# Access Compliance Report

## Public Rights-of-Way

Intersection ID: 21577	Main Street: SARDIS_CROSSING_DR	Cross Street: GALLERIA_BV	Location: SE
ADA ID: BD1016B57594	Ramp Type: PerpDiag	Initial Pass/Fail: Fail	Overall Compliance: No
Severity Score: 33.75			
Codes/Mitigation Info/Possible Solution		Field Measurements/Component Compliance

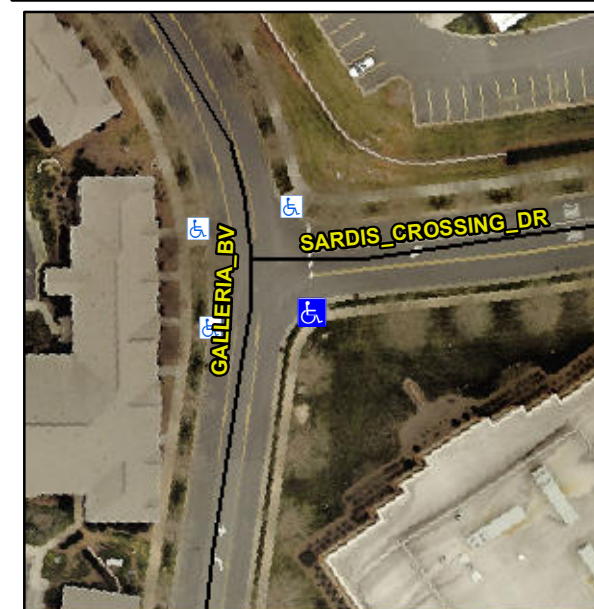
**R304.5.1, R304.2.2, R304.5.3**

Compliance	Description	Data	Compliance	Description	Data
N/A	Ramp Length (in)	47.0	No	Ramp Slope (%)	8.7
No	Ramp Width (in)	40.0	No	Ramp XSlope (%)	5.4
N/A	Flare Type LT	N/A	N/A	Flare Type RT	N/A
N/A	Flare Slope LT (%)	N/A	N/A	Flare Slope RT (%)	N/A
N/A	Flare Traversable LT?	N/A	N/A	Flare Traversable RT?	N/A
N/A	Landing Length (in)	N/A	N/A	DWS Provided?	N/A
N/A	Landing Width (in)	N/A	N/A	DWS Contrast?	N/A
N/A	Landing Slope (%)	N/A	N/A	DWS Length (in)	N/A
N/A	Landing X Slope (%)	N/A	N/A	DWS Full Width?	N/A
N/A	Landing Curb? (Y/N)	N/A	N/A	DWS Offset (in)	N/A
N/A	Shared Landing?	N/A			
N/A	Gutter Ponding?	N/A	N/A	Gutter Slope (%)	N/A
N/A	Gutter Lip Ht (in)	N/A	N/A	Gutter X Slope (%)	N/A
N/A	Painted X Walk1?	No	N/A	Painted X Walk2?	No
	X Walk 1 Direction	To N		X Walk 2 Direction	To W
N/A	X Walk 1 Width (in)	N/A	N/A	X Walk 2 Width (in)	N/A
	X Walk 1 Slope (%)	0.5		X Walk 2 Slope (%)	4.5
	X Walk 1 X Slope (%)	2.4		X Walk 2 X Slope (%)	0.3

**Remove & Replace Curb Ramp With Two New Directional Ramps or Equivalent.**
